RE: BALLINA QUAYS

Thank you for the invitation to review our previous advice regarding revetments within Ballina Quays. I have outlined below the important points that were considered in the initial advice of 1995 and how these may have changed in the intervening period. Lastly, I have indicated how some of these changes may lead Council to review its previous practices.

Figure 1 Ballina Quays Overview (Nearmap 11 June 2019)

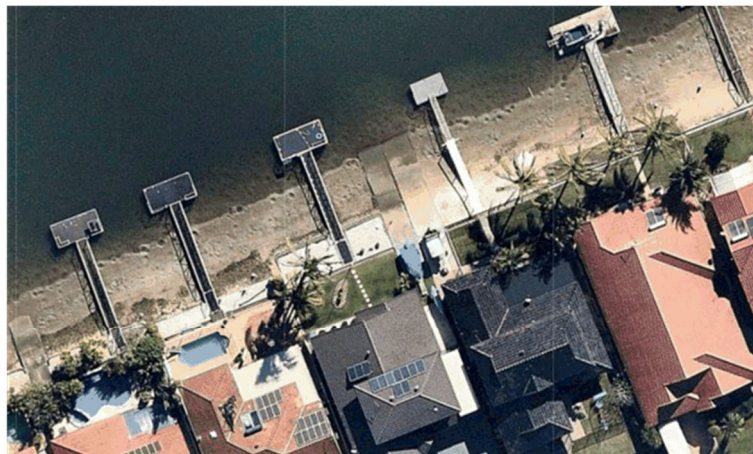
- Longshore transport is evident along the canal adjacent to Burns Point Ferry Road e.g. scalloped beaches and sand buildup at stormwater outlets, and is most likely due to wind fetch across the river and possibly boat wake;
- There is little evidence of longshore transport in the other canals as evidenced by relatively straight beaches;
- Therefore, the consistent revetment line approach is most appropriate for the Burns Point Ferry Road canal.

In conclusion, this review has found that evidence of longshore transport is present along the Burns Point Ferry Road canal but not in the secondary canals. Profile flattening appears reasonably consistent throughout the system. Therefore, it is recommended that a consistent revetment alignment of 2m from the kerb be maintained for the straight section of the Burns Point Ferry Road canal. For the secondary canals a consistent revetment alignment is not as critical, however significant extension past the 2m alignment may involve more formal revetment design considerations and some loss of equity where major variations between adjacent blocks causes aesthetic issues.
